Why switch to new DSLC-2XT & MSLC-2XT ?

Clemens - 2023-04-19 - MSLC-2

8440-2299 DSLC-2XT

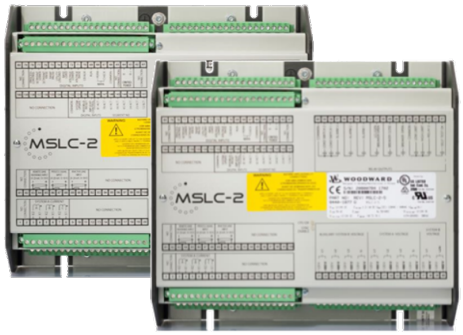
- same form factor
- same mounting dimensions
- only one part number for DSLC-2 and MSLC-2XT
- up to 690VAC direct sensing
- ../1A & ../5A current sensing
- Drop-in Replacement
- Class 1 kW sensing
- Higher galvanic isolation of PID outputs
- One additional ETH-C port
- Interoperable with old DSLC-2/MSLC2
- Manuals & configuration files stored on control
- USB configuration
